## Modification instructions for TStik Rev 2.0 boards Document Rev 1.0

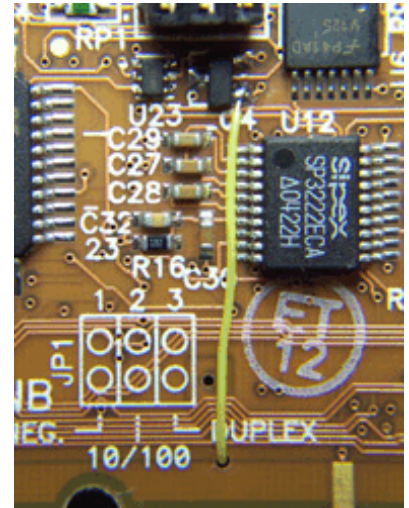
1. Solder one end of a wire to the gate of Q4.
  - a. Please use only the yellow 30AWG wire that we provided.

2. Thread the other end of the wire through the hole drilled under the “D” in “DUPLEx”.

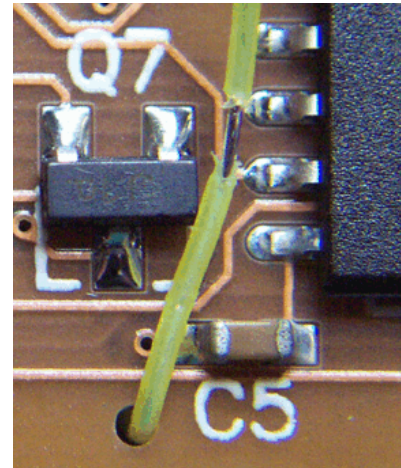
3. Measure the length of wire to the gate of Q7 and separate the insulation at that point, without stripping the wire, leaving about 1/16th inch of exposed bare wire.
4. Solder the exposed wire segment to the gate of Q7.

5. Measure the length of wire to the gate of Q6 and again separate the insulation at that point.
6. Cut the wire so it ends above the pin and solder it down.
